Demand Side Participation Forecast Methodology

June 2020

Draft determination

Figure 1 NMI inclusions and exclusions in DSP definition

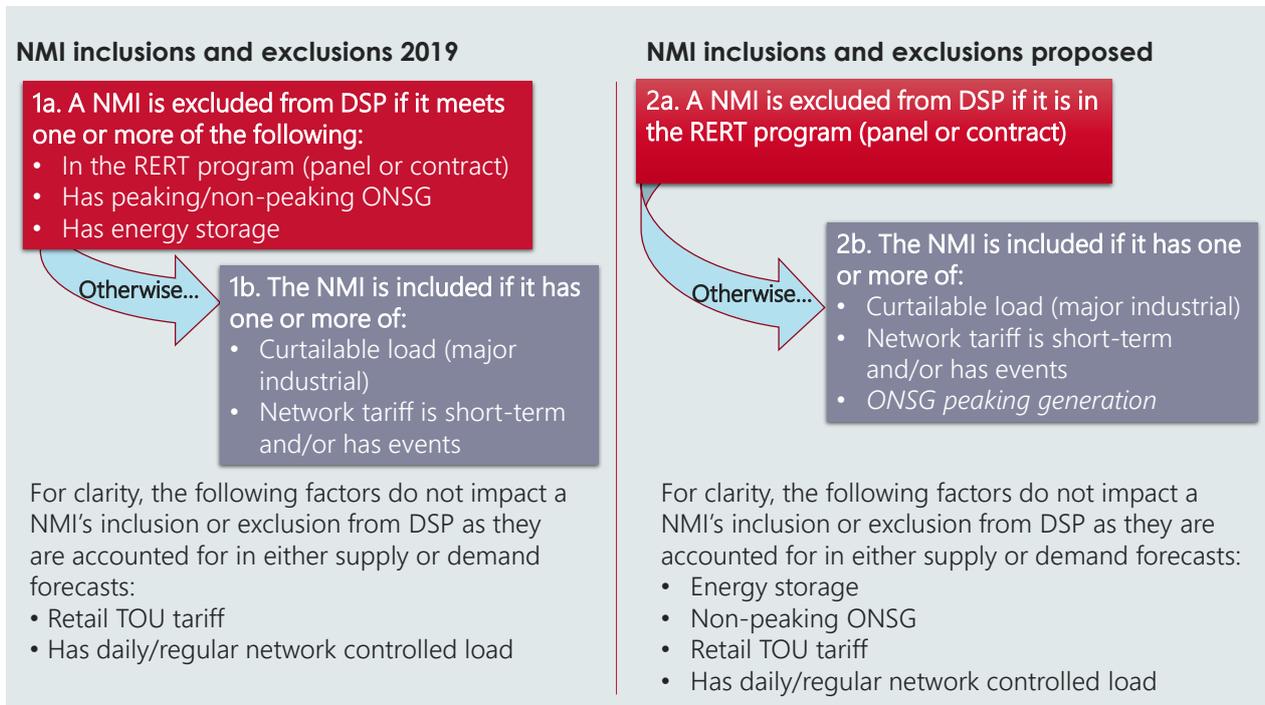
Stakeholders sought a robust and well communicated definition of which National Metering Identifiers (NMIs) are included in the DSP forecast. Enel X considered that this would “avoid double counting as well as avoid duplicated effort on behalf of participants”. ERM Power recommended “the methodology set out in more detail the process by which AEMO will allocate different loads (NMIs) to different DSP sub-types”.

Once it is clear which NMIs are included in DSP forecasts, the methodology should detail the level of aggregation at which the DSP response is calculated.

The submissions highlighted the need for clarity in detailing which types of electricity sites (NMIs) are included and excluded from DSP calculations. AEMO agrees this is beneficial and that it needs to clarify inclusions and exclusions, as well as develop an explanation that is easy to understand.

AEMO considers that the following logical structure best summarises inclusions and exclusions:

- Some factors invalidate (or exclude) a NMI from being considered for DSP forecasting purposes.
- Otherwise, a NMI is considered for DSP forecasting purposes if it has one or more of the other factors.
- For clarity, other factors that may be associated with a NMI are noted as not being relevant in determining the inclusion or exclusion of that NMI from DSP as these factors are already included in either the demand or supply forecasts.

The following diagram summarises inclusions and exclusions for the 2019 DSP process and the proposed changes for 2020 onwards.

The NMI-centric structure of the above figure shows that a NMI in multiple DSP programs is only counted once. This is superior to a DSP program-centric explanation, which results in a set of NMI's for each DSP program, and thus necessitates detailed treatment of potential overlaps.
